## CITY of NOVI CITY COUNCIL

**SUBJECT:** Consideration of the request of Hotel Baronette for SP09-08, Preliminary Site Plan and Shared Parking Study approval. The subject property is approximately 6.29 acres of land located in Section 14, on the east side of Novi Road, between I-96 and Twelve Mile Road in the RC, Regional Center District. The applicant is proposing to add a three-story 5,688 square foot addition to the existing Hotel Baronette, extend the patio area of the existing restaurant, and eliminate 26 parking spaces from the existing parking lot.

The Baronette a Renaissance Hotel by Marriott  
FKA Hotel Baronette  
SP #09-08

**SUBJECT: Hotel Baronette / Marriott Renaissance Renovation, SP#09-08A,  
Traffic Review of Supplemental Traffic Impact Study of May 18, 2009**

Hotel Baronette at Twelve Oaks Mall, Novi

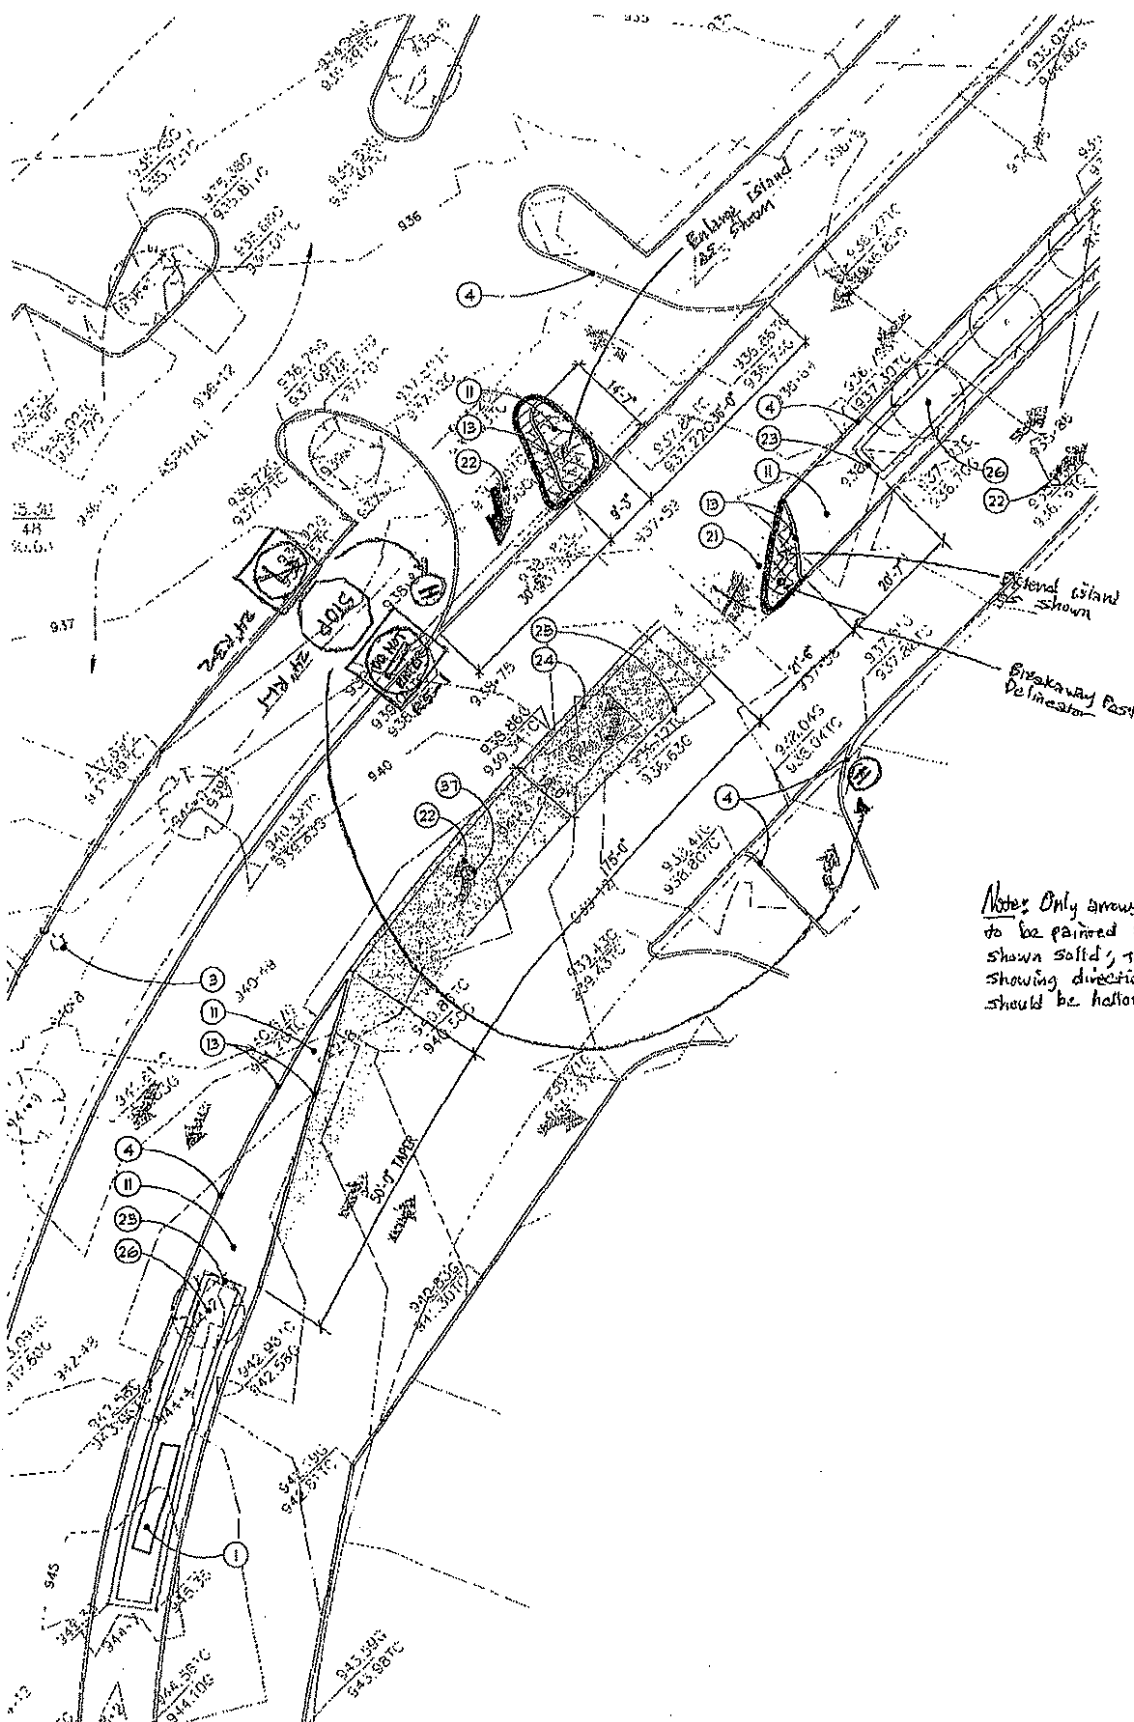
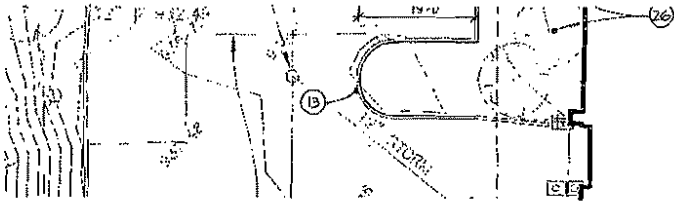
11. The plan proposes to reduce the size of the existing island in the hotel's south driveway and allow entering left turns from the mall entrance drive. **To enhance that island's visibility and provide a somewhat better physical deterrent to exiting left turns (at a location where such turns would be disruptive to mall traffic), the island should be enlarged and the exiting drive narrowed; see the first attached plan mark-up. Also, to further discourage exiting left turns, the median nose east of the hotel drive should be extended further west (also shown in the mark-up).**

12. No later than the final site plan, appropriate traffic control devices (signs and pavement arrows) should be proposed at both the modified site driveway and the existing driveway across the entrance road from the site driveway. Our recommendations in this regard are shown on the attached plan mark-up.

*Note: Only arrows meant to be painted should be shown solid, those only showing directionality should be hollow.*

**2 New Addition Layout Enlargement Plan**  
 L001 SCALE: 1" = 20'-0"

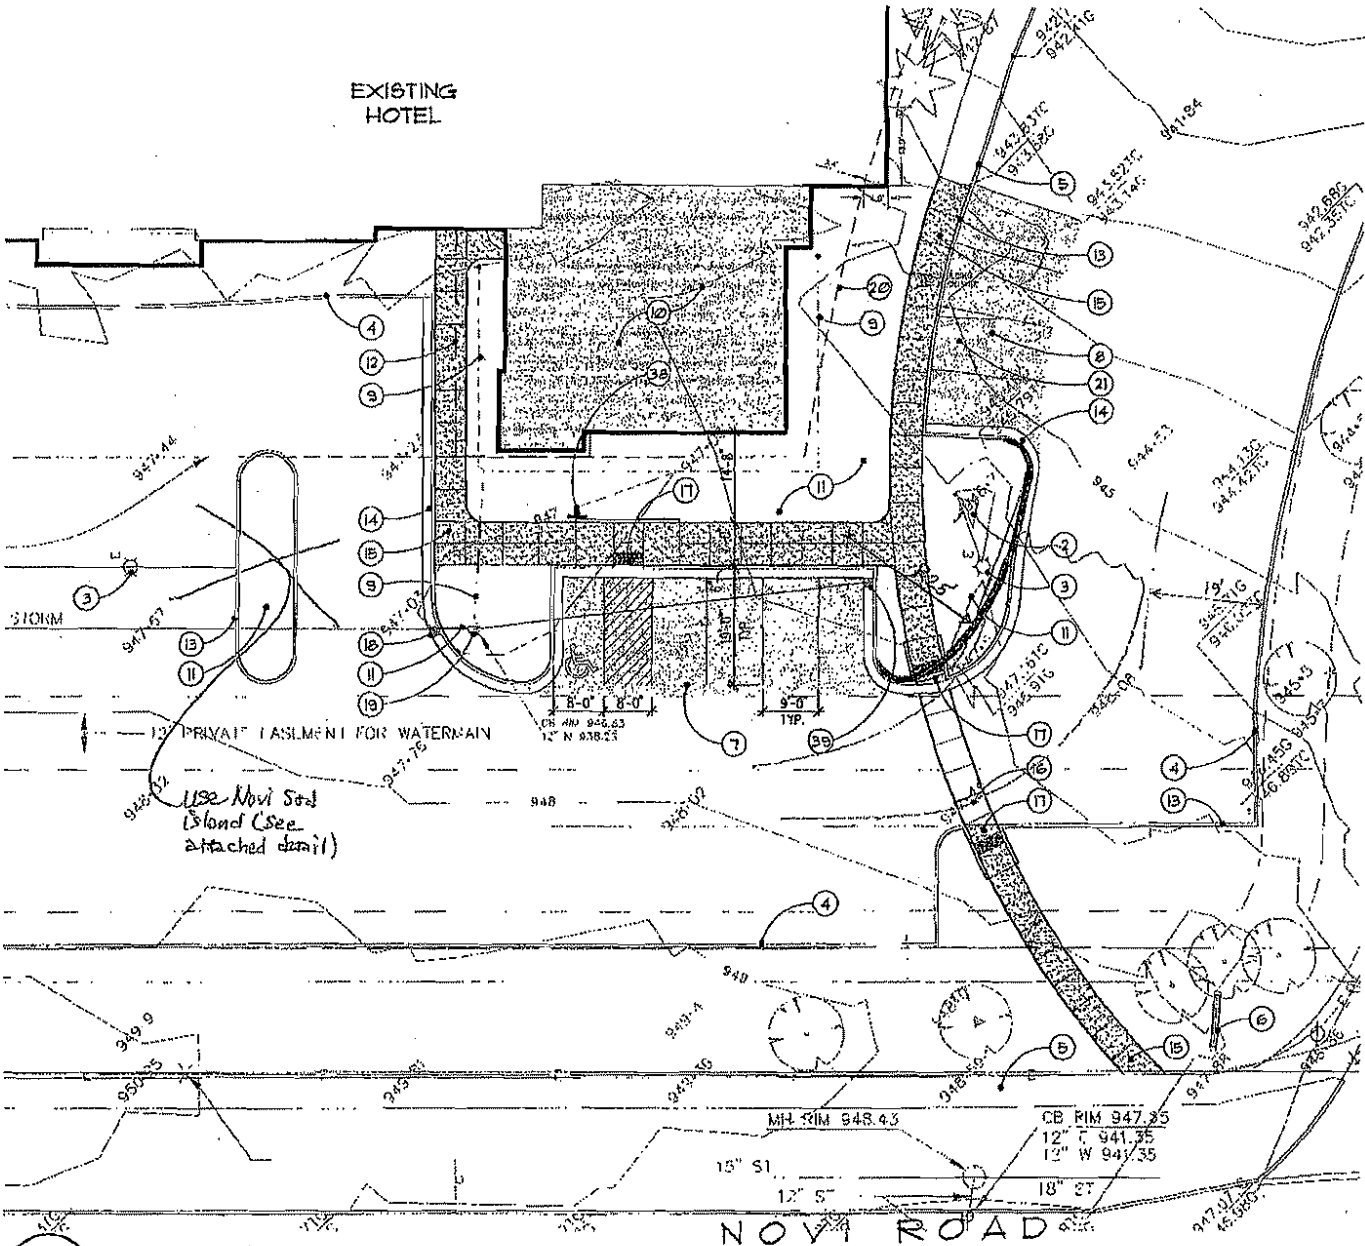
13. We were unable to find any dimensions in the plan set for the proposed new curb radii near the proposed building addition. It appears, however, that the *inside corner radius* between the west and south parking aisles is only 15 ft. Our review with turning templates confirms that a larger radius would be required to facilitate fire truck circulation in the event cars are parked along the south side of the lot. Also, the new end island nominally north of the addition has semicircular ends and parallel sides, contrary to the City's Zoning Ordinance (Sec 2506.13).

14. **To address the two deficiencies described in comment 13, we recommend that (a) a 25-ft inside corner radius be used, as shown in the second attached plan mark-up, and (b) the new parking lot end island be designed per the attached standard detail sheet.**
